### **Addendum to 'EIA Scoping Report - Hillingdon Water Sports Facility and Activity Centre (February 2023)'**

- 1.1 This note provides a response requests for clarification and further information raised by LBH in relation to the EIA Scoping Report for the Hillingdon Water Sports Facility and Activity Centre (HWSFAC) proposals submitted to London Borough of Hillingdon (LBH) on 23<sup>rd</sup> February 2023 (reference: 2382/APP/2023/525) together with a request for a formal scoping opinion. The issues raised were set out in a draft Scoping Report review report and were discussed with the LBH Planning Officer and Arup (acting as EIA advisors to LBH) at a meeting on 18<sup>th</sup> April 2023.

Figure 4: Zone of Theoretical Visibility

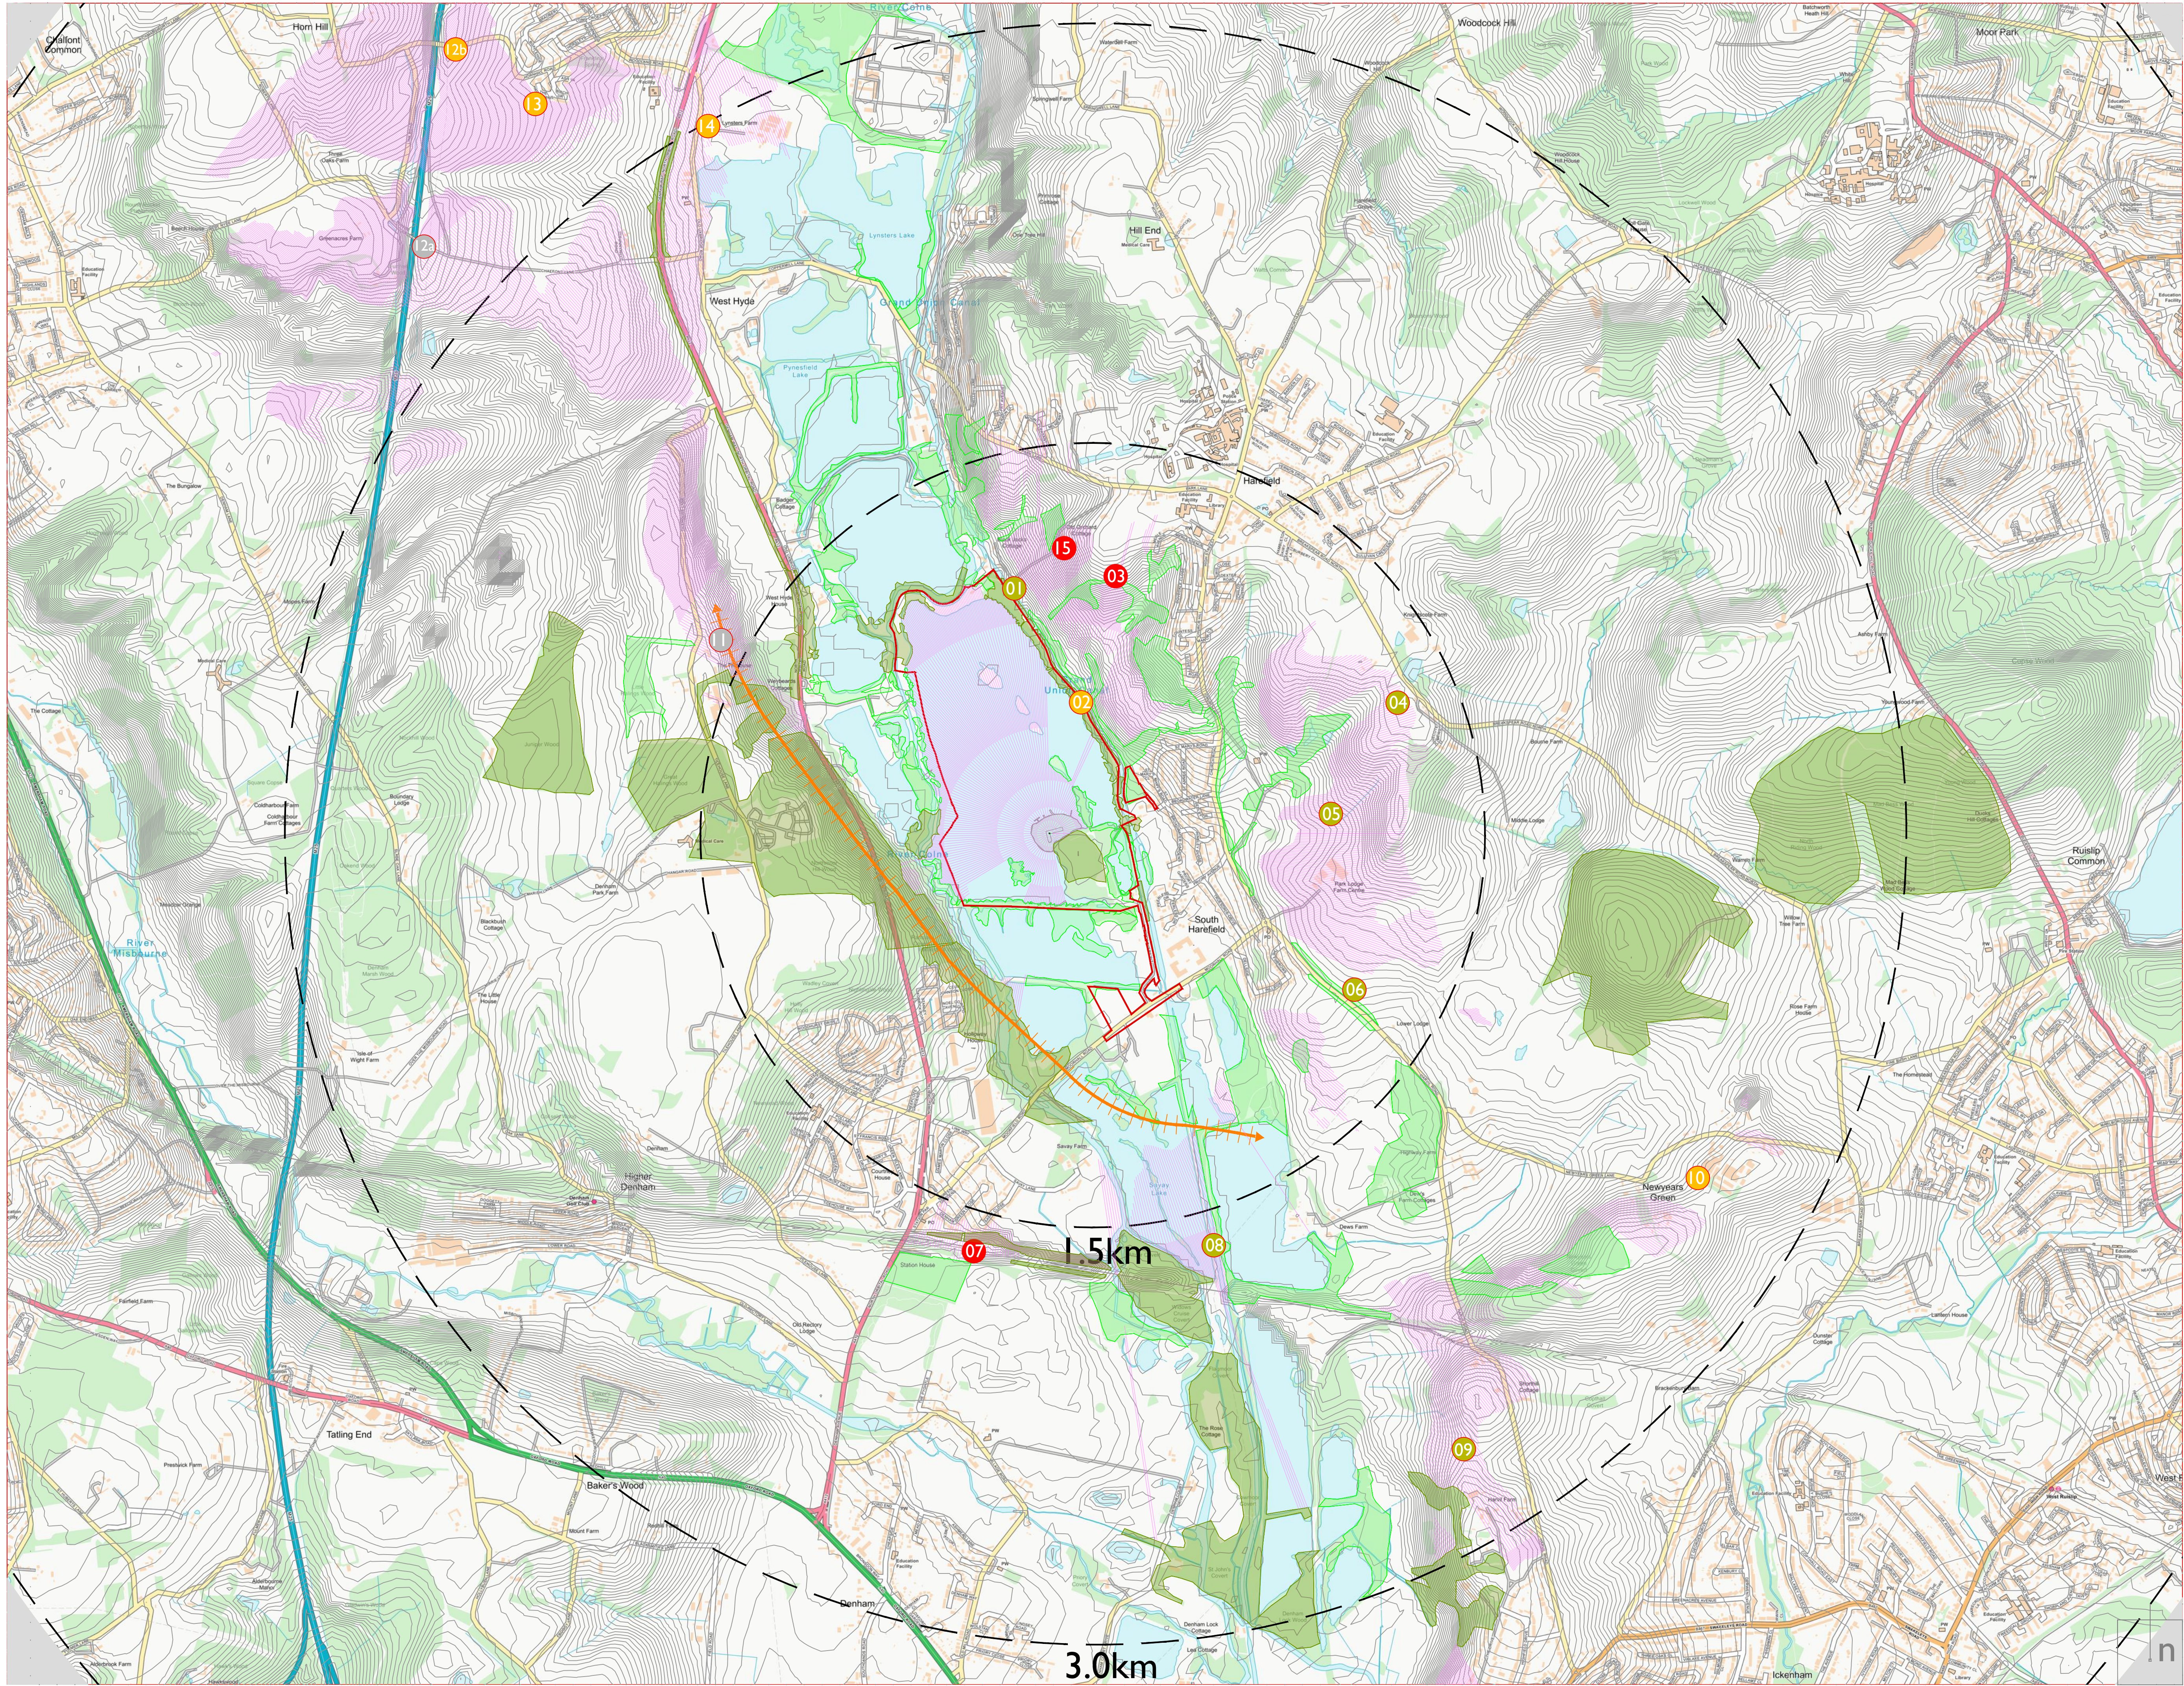
- 9.4 A 3km radius Zone of Theoretical Visibility (ZTV) study and field study has been undertaken to establish where views or part views of elements of the Proposed Development may be experienced from (see Figure 4, Annex 1). The following viewpoints have been agreed with LBH's Urban Design Officer for inclusion in the assessment:
